MANDATORY SERVICE BULLETIN

Object : Additional indications concerning the wing locking.

IS-28B2/EO-7

FLIGHT AND MAINTENANCE MANUAL IS-28B2

Fig. 6.2.1 Main junction tightening

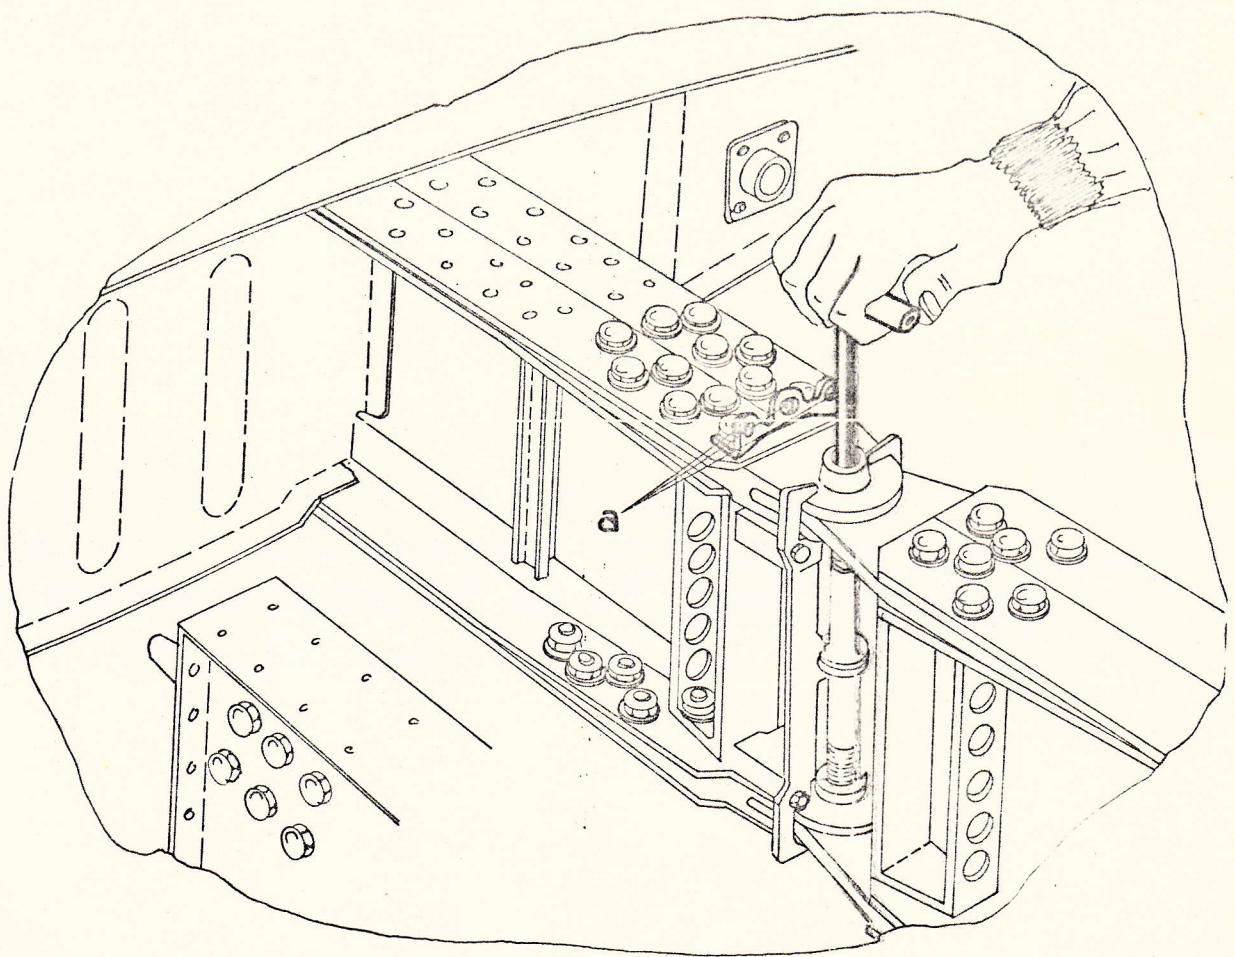
The junction wrench shall be actuated by hand only (without using extensions).

During the whole tightening operation two persons shall raise and lower the wing extremities simultaneously to facilitate the cones lead in.

Match the wrench into one of the three locking holes indicated by "a" by removing, twisting and inserting it, until the correct position is found (sometimes a slight tightening is also required).
